**APPENDIX J**  
**: INFORMATION OF CLASS II PERMISSIVE CHANGE**

### Information of Class II Permissive Change

EUT Type: Base station  
Model Name: MRF-260, MRF-260DBL  
FCC ID.: OZ5URCMRF260  
Applicant: OH SUNG ELECTRONICS CO., LTD.

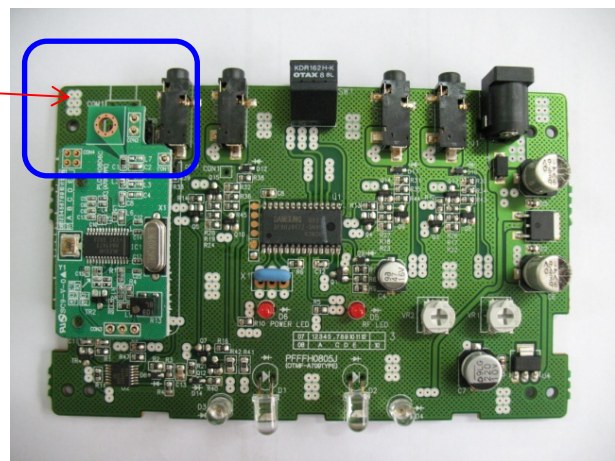
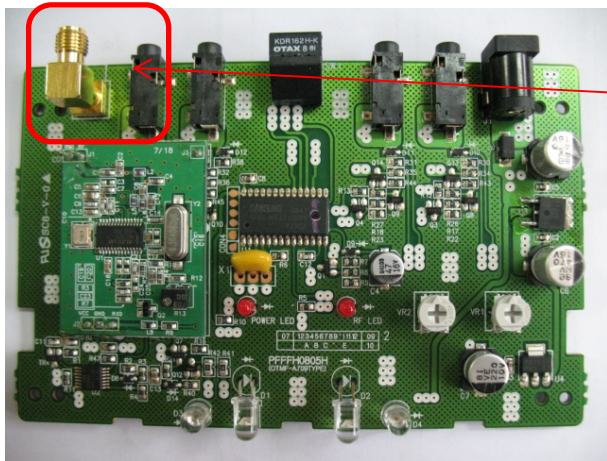
-. Change Antenna Connecting type (SMA type → Fixing at PCB with screw)

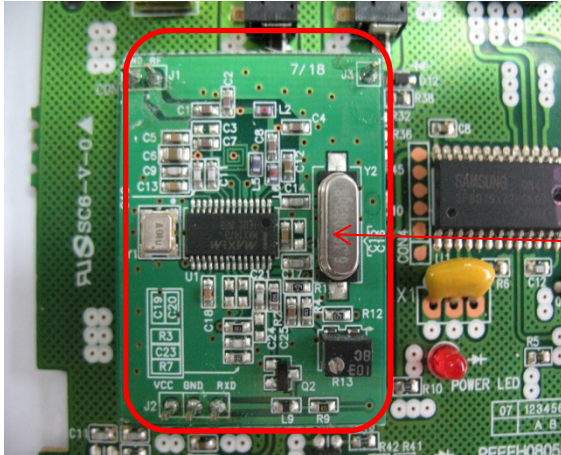
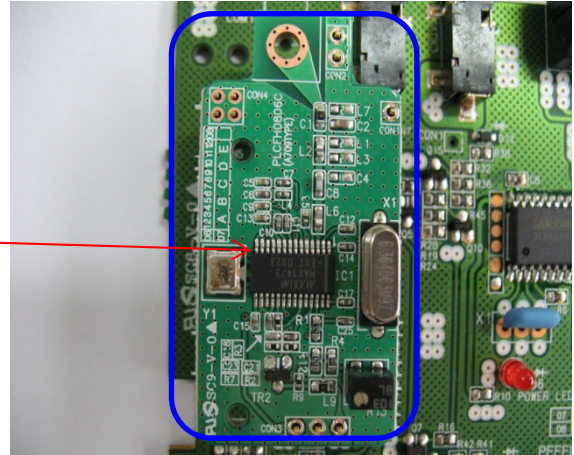
**- Change RF module part**
